Regarding: 90 Saghalie Road. - Aquara Seniors Living Project.
Response to COTW comments from August 2, 2018 & ADP Comments from May 9, 2018.
Date: October 29, 2018.

A. Committee of the Whole Motion

B. Advisory Design Panel Motion

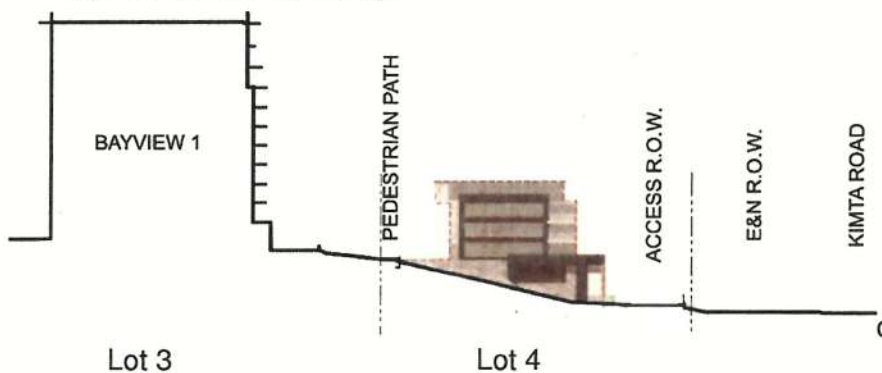
3. In addition, the buildings should be terraced back in a minimum of 2.4m increments along the Kimta and Tyee Roads frontages to soften massing impact.

- We have redesigned the main floor and the fifth floor to create a more pronounced stepped building form, consistent with the design guideline and the natural topography of the site.

The fifth floor has been set back a minimum of 2.4m from the floors below along the entire length of Kimta to create the terracing effect. While this does shift the top floor closer to the adjacent buildings to the north, in our opinion the 2.4M shift will have little perceptible difference on the separation to Bayview site, and the remaining building separation is more than adequate. With the shift in the upper floor, the the building separation between the Aquara building and Bayview (East) Townhomes is 79', to the (West) Townhomes is 75', and to the Bayview One tower is 135'. The stepped fifth floor has been designed to minimize the visual impact on the north side through individual articulated balconies (rather than one long balcony). New structural columns are expressed along the north façade to create a more interesting building design.

We have added an additional step in the building massing at the ground floor facing Kimta and the lower floors facing Tyee, by introducing new curved frame elements into the building design. The curved frames continue the curvilinear ground plane and planter treatment that we have introduced throughout the entirety of both building frontages, which is a response to the organic forms in the existing site topography and the curved profile of the frontage road.
